TRANS/WP.29/2003/68  
17 July 2003

PROPOSAL FOR DRAFT SUPPLEMENT 6 TO THE 01 SERIES  
OF AMENDMENTS TO REGULATION No. 52

(Small capacity passenger vehicles, M2 and M3 category)

"Figure 7

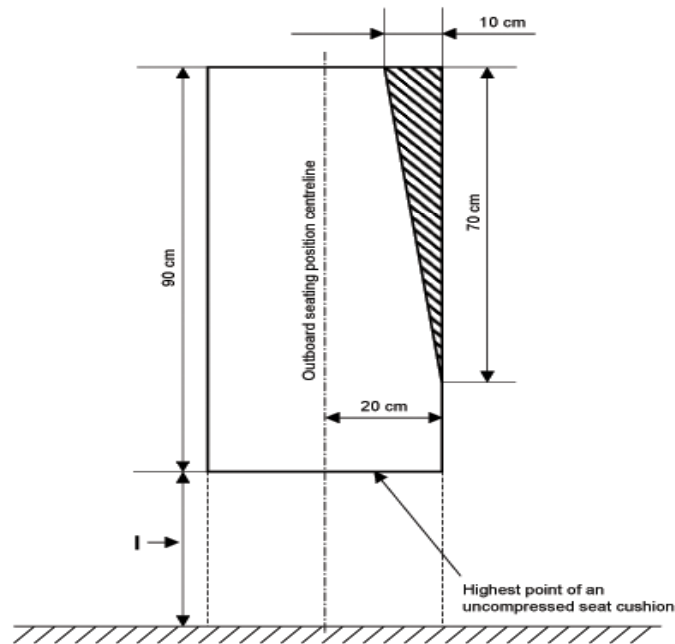
"5.7.8.1.3.2 Intrusion of a structural member provided that the intrusion is included within a triangle whose peak is situated 70 cm from the top and whose base 10 cm in width and situated in the upper part of the space in question, adjacent to the side wall of the vehicle (see annex 3, figure 7)."

Annex 3, Figure 7, amend to read:

Permitted intrusion of a structural member

(see paragraph 5.7.8.1.3.2)

I (cm) min.
40-50
(35 cm at wheel arches and engine compartment)
